MFN 07-310

Docket No. 52-010

Subject: **Response to Portion of NRC Request for Additional Information
Letter No. 85 - Containment Systems and Emergency Core Cooling
Systems - RAI Numbers 6.2-144, 6.2-145, 6.2-146, 6.2-147, and 6.3-66**

RAI Numbers 6.2-144, 6.2-145, 6.2-146, 6.2-147, and 6.3-66

Figure 6.2-144-1: Effect of Wetwell Pressure on the GDCS Initiation Timing (GDCS Injection Line Break, 1 GDCS Injection Valve Failure)

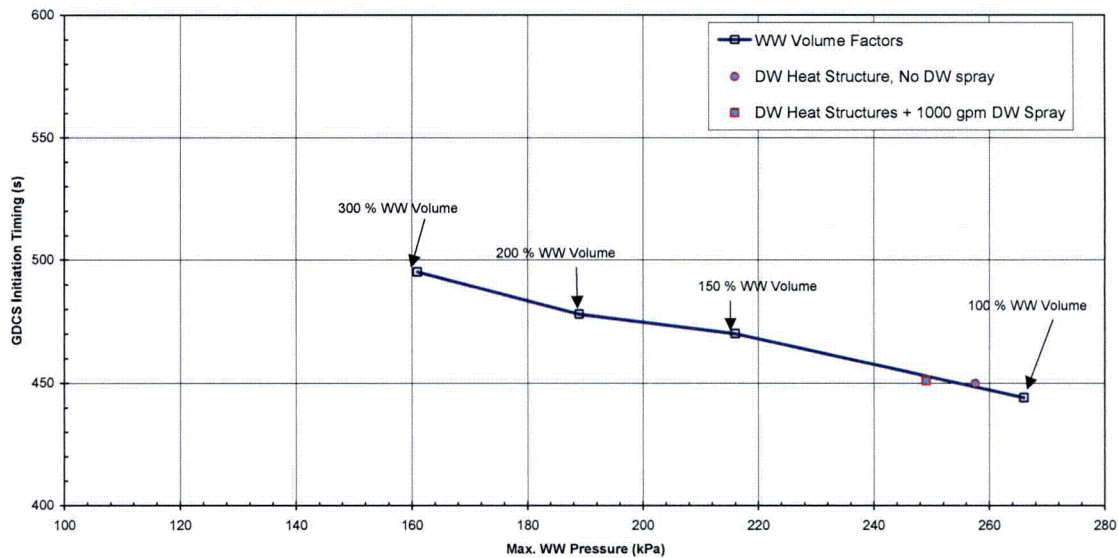
DCD, Tier 2, Revision 2, Section 6.3 assumed the availability of the containment back pressure in determining the minimum water level in the reactor pressure vessel (RPV) following a LOCA. The depressurization of the RPV and thus the initiation of the Gravity Driven Cooling System (GDCS) is dependent on the assumptions used for determining the containment back pressure. However, the analyses are inconsistent with Standard Review Plan (SRP) Section 6.2.1.5, "Minimum Containment Pressure Analysis for Emergency Core Cooling System Performance Capability Studies," Revision 2, July 1981 and Branch Technical Position CSB 6-1, "Minimum Containment Pressure Model for PWR ECCS Performance Evaluation." Although, CSB 6-1 was developed to evaluate the performance of emergency core cooling system of a pressurized water reactor, most of its guidance is also applicable to ESBWR for determining the performance of the GDCS. Specifically, the input information for the model, active heat sinks (e.g., Fuel and Auxiliary Pools Cooling System operating on drywell spray mode), and passive heat sinks affect the containment back pressure. Please justify the containment back pressure used for determining the minimum RPV water level considering Branch Technical Position CSB 6-1.

Figure 6.2-144-1 shows the effect of the maximum wetwell pressure on the GDCS injection timing. The initiation time for the GDCS flow increases linearly as the wetwell pressure reduces. With the additional passive and active heat sinks, the GDCS initiation time increases by 7 seconds from the base case value.
